SUBJECT: NRC REQUIREMENTS FOR AUXILIARY FEEDWATER SYSTEMS AT ST. LUCIE UNIT 1

## ENCLOSURE 1

### ST. LUCIE UNIT 1

#### AUXILIARY FEEDWATER SYSTEM

Auxiliary Feedwater System  
St. Lucie, Unit 1  
Figure 1

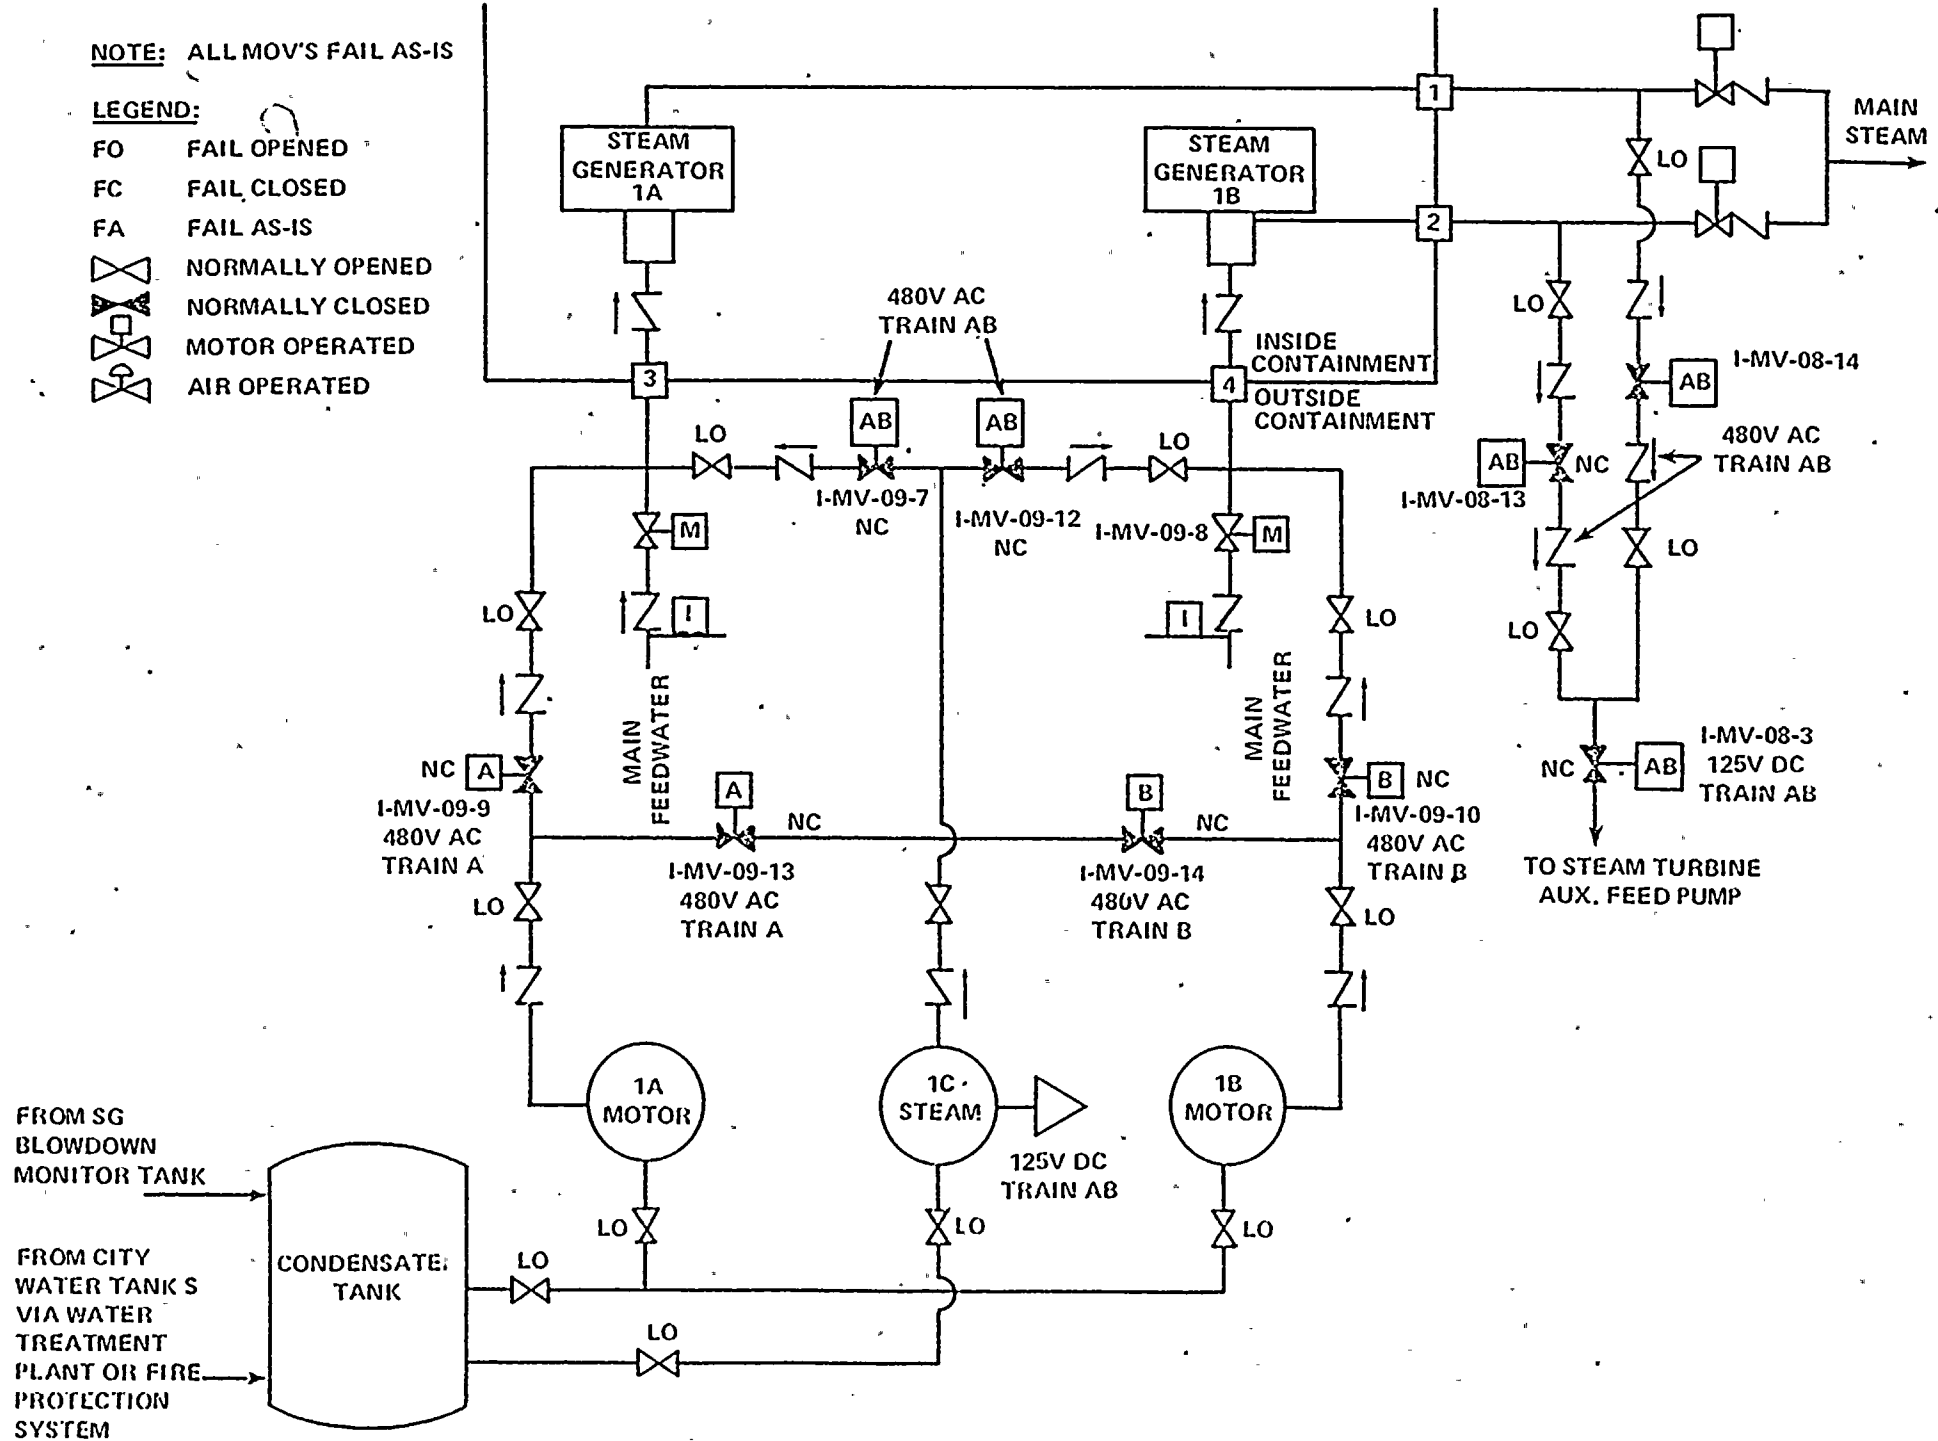
3. Recommendation - The present method of supplying water from the alternate water sources to the CST for the AFWS requires considerable operator action and is estimated to take approximately three hours to accomplish. The licensee should modify the design to provide means to supply water to the AFWS from the alternate sources within one-half hour or less.

4. Recommendation - The St. Lucie plant needs one full capacity train of AFW flow (2 motor-driven or 1 turbine-driven AFW pump) for safe plant shutdown. This AFWS design does not meet the high energy line break criteria in SRP 10.4.9 and Branch Technical Position 10-1; namely that the AFWS should maintain the capability to supply the required AFW flow to the steam generator(s) assuming a pipe break anywhere in the AFW pump discharge lines plus a single active failure. The licensee should (1) complete an evaluation assuming such an event and determine any AFW system modifications or procedures necessary to maintain the required AFW flow to the steam generator(s), or (2) describe how the plant can be brought to a safe shutdown condition by use of other available systems following such a postulated event.
